DUKE POWER COMPANY  
DESIGN ENGINEERING DEPARTMENT

SQRT AUDIT RESOLUTIONS  
CATAWBA UNIT 1  
FOR  
SQRT AUDIT CONDUCTED  
MARCH 13-16, 1984

RESOLUTION SUBMITTAL DATE  
APRIL 17, 1984

CATAWBA NUCLEAR STATION  
SEISMIC QUALIFICATION OF SAFETY-RELATED ELECTRICAL EQUIPMENT  
RESOLUTION OF SQRT AUDIT ITEMS

FIGURE 4

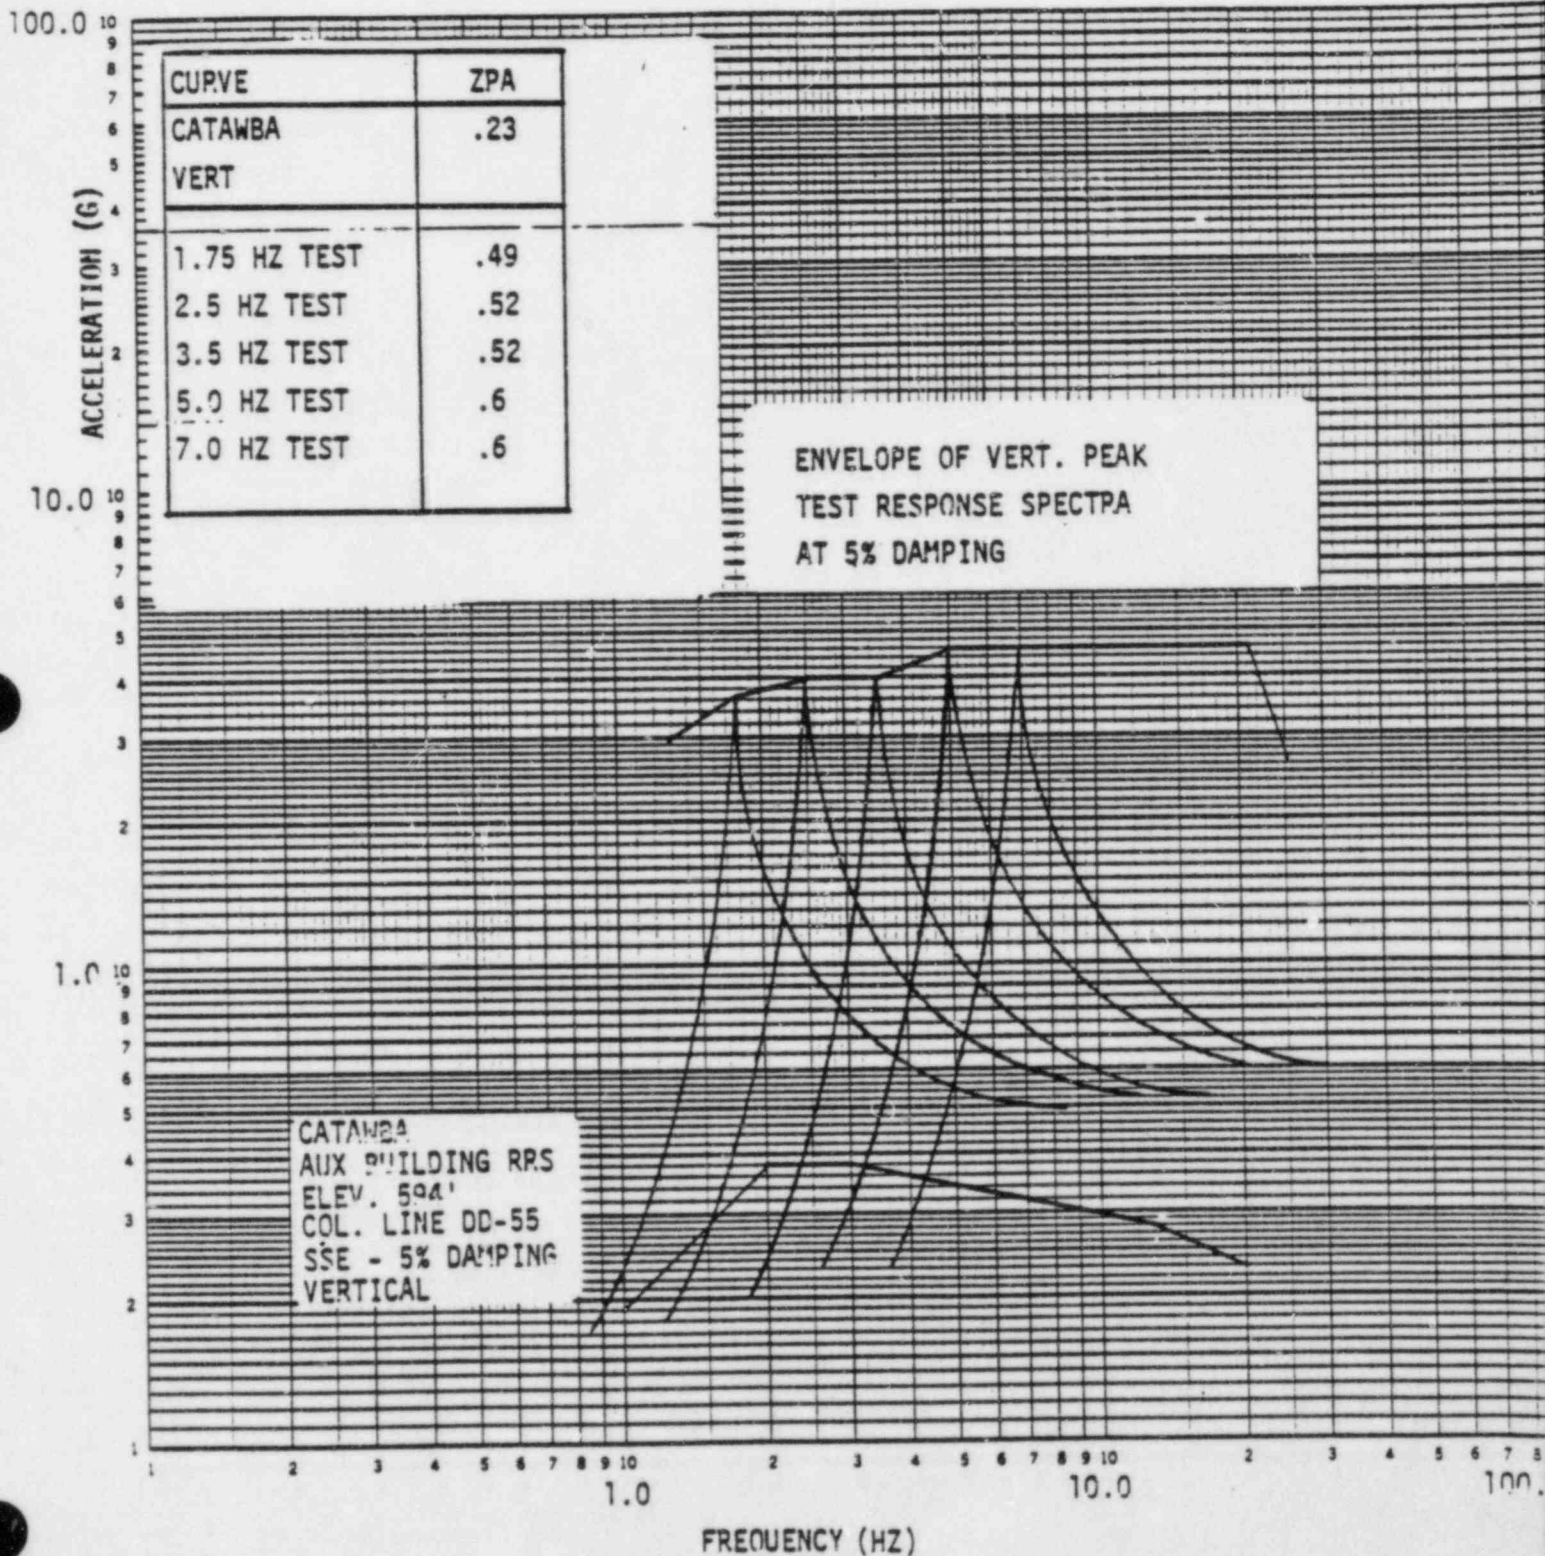
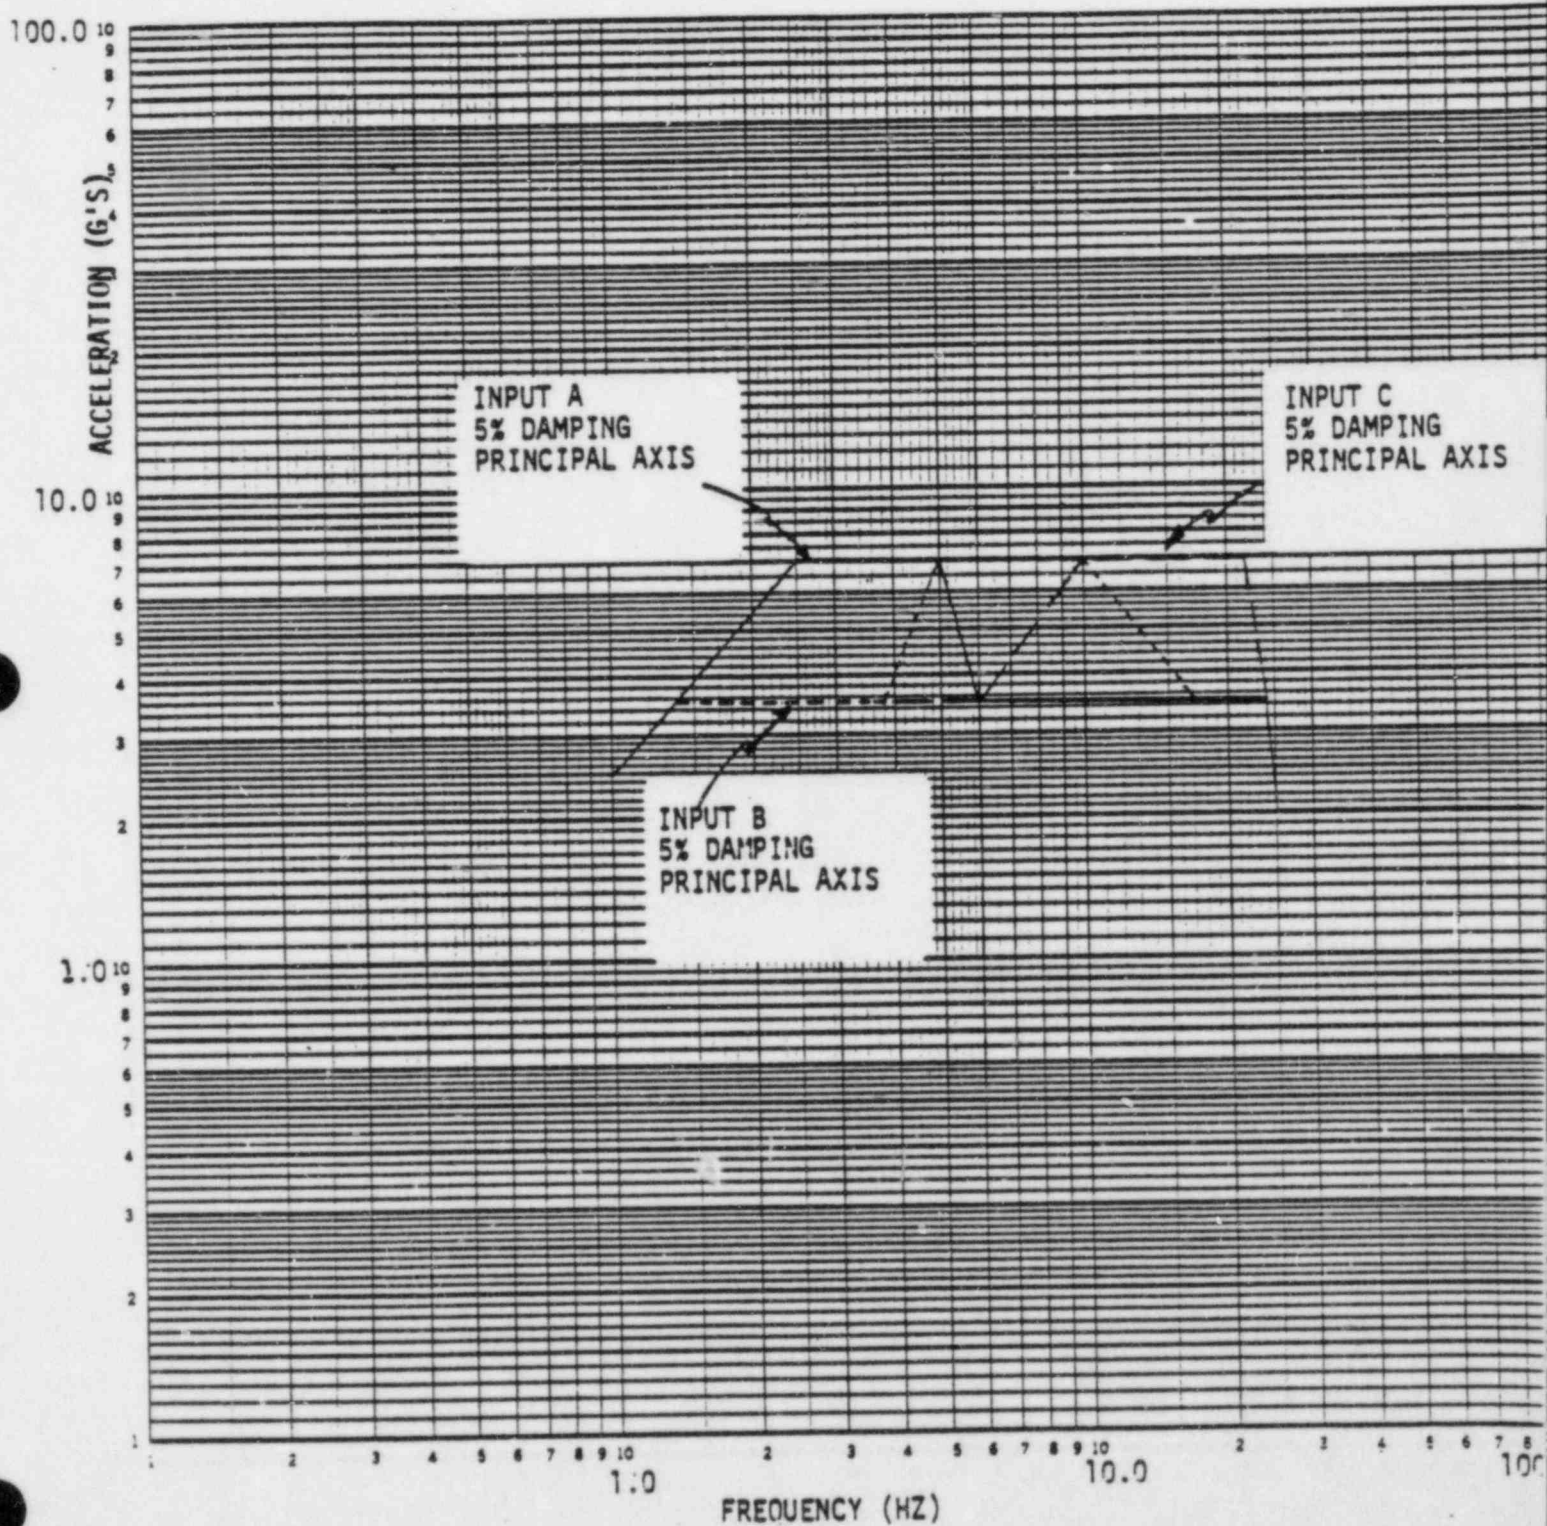
PART 1: There was no indication that this equipment was tested beyond 25 Hz. Westinghouse is to confirm that it was tested beyond 25 Hz or provide justification for this position.

PART 3: Provide an auditable link for qualification documents (i.e., qualified vs. installed).

RESOLUTION SUMMARY: At the time the seismic tests were performed and the WCAP 7817 written, 25 Hz was considered the upper frequency limit for testing (as noted in WCAP 7817 "Basis of Criteria," Page B-4). However, as a precaution against having to perform additional tests at higher frequencies at a later date, seismic tests were performed to an upper frequency limit of 35 Hz. During these added tests from 25 Hz to 35 Hz, no resonance frequencies were found and the sine beat acceleration was held constant at 0.2g. No mechanical changes in any equipment was observed and all electrical functions were normal during these additional tests. A record of the 35 Hz testing is in the Westinghouse detailed test data file.

RESOLUTION SUMMARY: A review of the SSPS furnished by Westinghouse was made with the view of selecting a standard SSPS for testing to establish criteria as stated in Section 1 of WCAP 7817. As a result, the SSPS tested was chosen as being representative of the SSPS supplied to Duke Power Company for the Catawba plant. Therefore, since this identified equipment was subjected to type tests under simulated seismic accelerations which envelope the Catawba specific seismic requirements, the Catawba equipment is qualified based on WCAP 7817 and the test data cited in Part 1 of this response. This response confirms the applicability of the testing in WCAP 7817 to the specific SSPS for Catawba, consistent with the requirements of IEEE-34-1971.
